Reviewer #2

This manuscript analyzed G6sulfur using CNRM-ESM2-1 to estimate the impact of injected sulfate aerosol on two types of renewable energy: photovoltaic (PV) and concentrated solar power (CSP). It concluded that solar power production potential would decrease under G6sulfur relative to SSP8-8.5 and SSP2-4.5, with CSP efficiency experiencing a greater reduction than PV. This reduction is mainly attributed to the significant reduction in direct solar radiation, which strongly affect the efficiency of CSP, while the increase of diffuse radiation under G6sulfur slightly improves PV efficiency. For both CSP and PV, the cooling effect and reduced cloud coverage under G6sulfur have a positive influence on solar power production. This study is important to fill the gap in understanding how solar radiation modification impacts renewable energy and is a good fit for Earth System Dynamics.

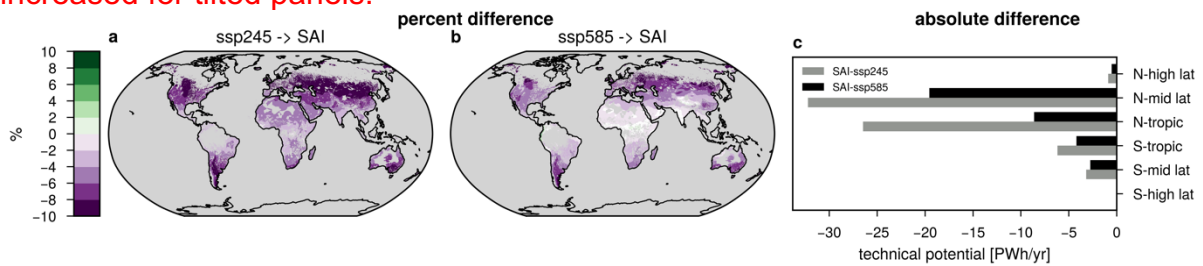
Equation 1: just to confirm that PV-TP takes direct and diffuse radiation with the same efficiency, since RSDS is used. Does PV panel need to adjust certain setting for better performance under cloudy days?

Equation 3: should c_3 be different for direct and diffuse radiation?

Yes, PV-TP takes direct and diffuse radiation with the same efficiency. On cloudy days panels would likely adjust the tilt of the panel.

We have added another mode of PV-TP calculation (PV-TP_{fixed}) to the study that takes direct and diffuse radiation into account separately by considering solar geometry and a tilt of the panel. The main conclusion of the paper does not change with this updated version of the PV potential calculation but it shows even larger relative and absolute reductions in the high latitudes than for horizontally aligned panels (Figure 1). This is because the tilt of the panel increases the amount of direct radiation that can be harvested. However, SAI modifies the fraction of direct and diffuse radiation to entail a larger diffuse fraction and therefore the advantage of the tilt is reduced under SAI versus the SSP scenarios. Hence, relative reductions in

high latitudes under SAI that already exist for horizontally aligned panels are further increased for tilted panels.
